**From:** [Brissette, Renee C.](#)  
**To:** ["Jeremy Shell"](#)  
**Cc:** [Rick Beltramo](#)  
**Subject:** RE: Paseo Marketplace  
**Date:** Thursday, May 18, 2017 4:14:00 PM  
**Attachments:** [SKM\\_C554e17051815590.pdf](#)

We intend to resubmit to hydrology for DRB project number 1010675 today. Are you available this afternoon to quickly go through the changes?

UNDERGROUND WATER QUALITY POND.

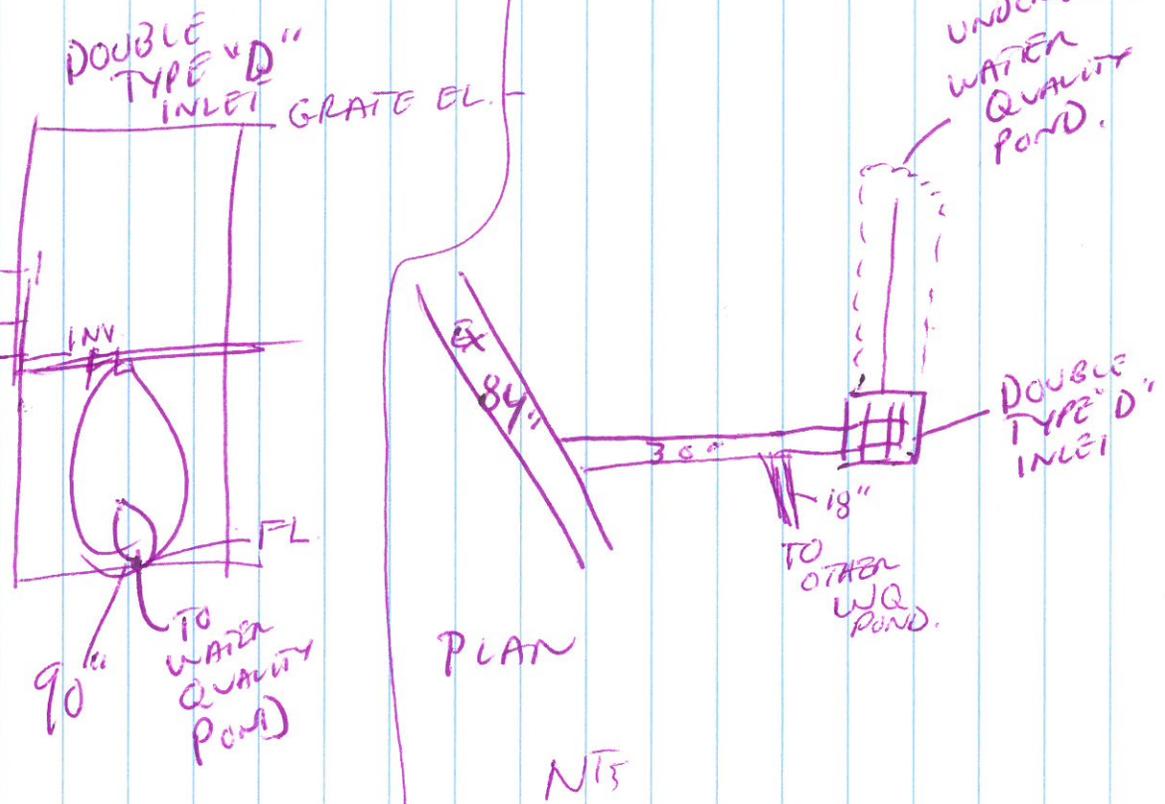
Sorry to keep bugging about this. The underground perforated pipe is for **water quality volume**. Therefore, please see my sketch. Can you provide the calculation for the 100 year HGL through the storm system. Also two profiles (one from the exist 84" through the 30" to the double Type D inlet –Subbasin 6 & one from the 18" through the MH to the double Type D inlet –Subbasin 3). Finally, please provide the details for the following:

- Connection to the exist 84"
- Connection of the 90" perforated pipe and the double Type D inlet
- Connection of the 90" perforated pipe and the MH
- Bedding detail of the 90" perforated pipe

**All of this should be placed on an additional sheet.** Please provide elevations and type of materials used in the details and profiles. Please note that this additional information will also be asked at DRB. The Connection to the 84" pipe should be included in the DRC workorder set, so please pass on the detail of this to that Engineer so it can be included. Also this connection to the existing 84" needs to be included in the infrastructure list for DRB approval.

- ★ CALC'S
- ★ DETAILS { CONNECTION TO EX. 84" TYPE "D" INLET. - SUB BASIN 6
- { CONNECTION OF 90" MA
- { CONNECTOR OF 90" MA. - SUB BASIN 3
- ★ PROFILE { 30" TO TYPE "D" INLET.
- { 18" TO MA TO TYPE "D" INLET.
